REMARKS

"Marked-up" drawings

FIG. 9

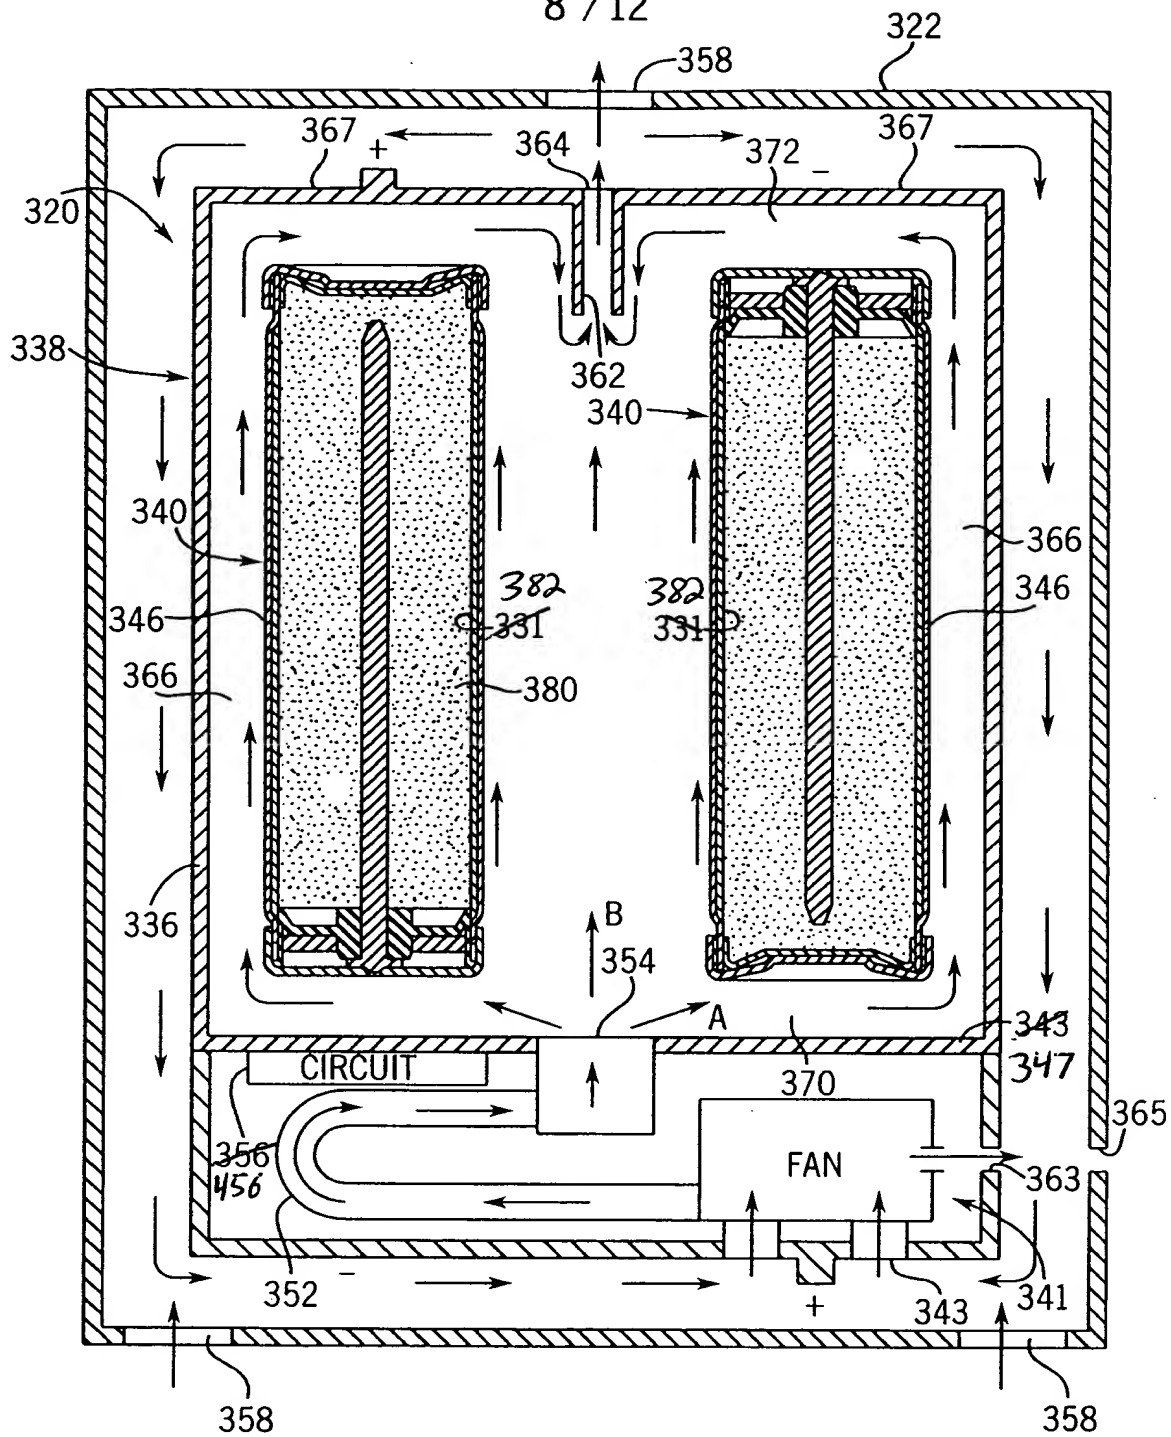
5) Reference numeral 31 of Fig. 4 is not described in the drawings. Reference numeral 31, 131, 231, and 331 of Figs. 4 and 7-9, respectively, have been changed to 82, 182, 282, and 382 for the purposes of consistency with Fig. 10.

6) The Office action calls out numerous reference numerals of Figs. 7-9 that are not mentioned in the description. However, Applicant notes that all identified reference numerals are incremented from reference numerals of Fig. 4 that are specifically called out in Paragraphs 61-68 of the specification. Applicant further directs the Examiner's attention to Paragraphs 78, 81, and 83, which specifically state that the reference numerals of 7-9 corresponding to like elements of Fig. 4 have been incremented by 100, 200, and 300, respectively. Accordingly, Applicant asserts the description of Fig. 4 is sufficient for the purposes of describing the like elements of Figs. 7-9.

2) Reference character 456 is not in the drawings. In the enclosed “marked-up” copy of Fig. 6, Applicant has drawn a red circle around reference numeral 456 to illustrate that numeral 456 was in the drawings as initially filed. Applicant further encloses marked-up copies of Figs. 4 and 7-9 that, in red ink, change the enumerated circuit “~~56~~, ~~156~~, ~~256~~, and ~~356~~” to “456” for the purposes of consistency with Fig. 6.
